HISTORIC PRESERVATION BOARD STAFF REPORT

105 NW 5th Avenue

Meeting	File No.	Application Type
July 3, 2019	2019-164	Certificate of Appropriateness (COA) & Class I Site Plan Modification

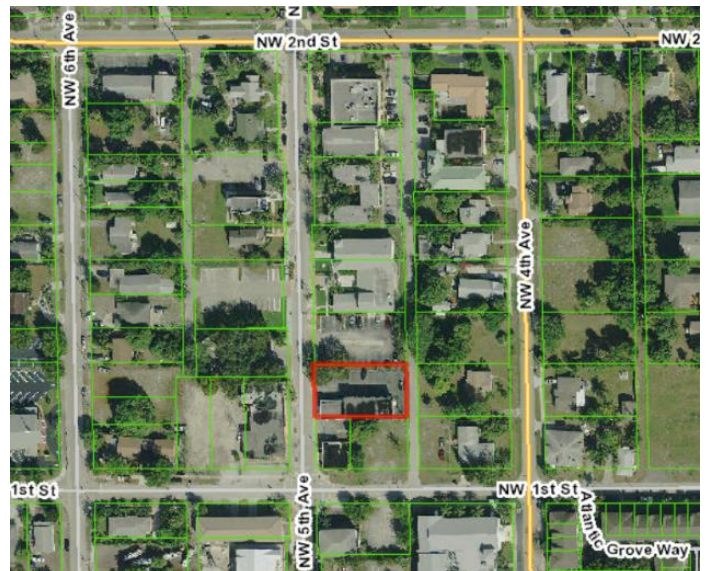
Standards 1, 2, 3, 5, and 9 are applicable. The applicant's proposal of the painting of the mural does not meet the intent of these Standards as it represents a modification of the exterior elevation that will obscure character defining architectural features, having a potential negative effect on the historic integrity of the West Settlers Historic District. Further, painting of a mural on historic structures may not be appropriate for structures in a historic district as it can compromise the integrity of the historic structure and overall streetscape of the district. It is noted, that HPB has approved a mural on a perimeter wall that was set back from the streetscape (103 NE 4th Street, Del-Ida Park). A mural in a historic district may be seen to be more appropriate on an accessory structure such as a perimeter wall or dumpster enclosure. Based upon the above, positive findings cannot be made to these requirements.

The Rhythm of Solids to Voids involves the relationship of a structure with existing buildings and structures within the subject historic district with particular attention is paid to the front façade. The proposed mural may compromise the rhythm of the structures along NW 5th Avenue and within the West Settlers Historic District.

The Relationship of Material, Texture and Color of the façade of a building shall be visually compatible with the predominant materials use in the historic buildings and structures within a historic district. There are no existing murals painted on structures within the West Settlers Historic District; thus, the proposal would not visually compatible with surrounding structures.

Based upon the above, the proposal mural may have a negative effect on the character of the neighborhood; and thus, may not be visually compatible with the West Settlers Historic District. A positive finding cannot be made to 4.5.1(E)(7).
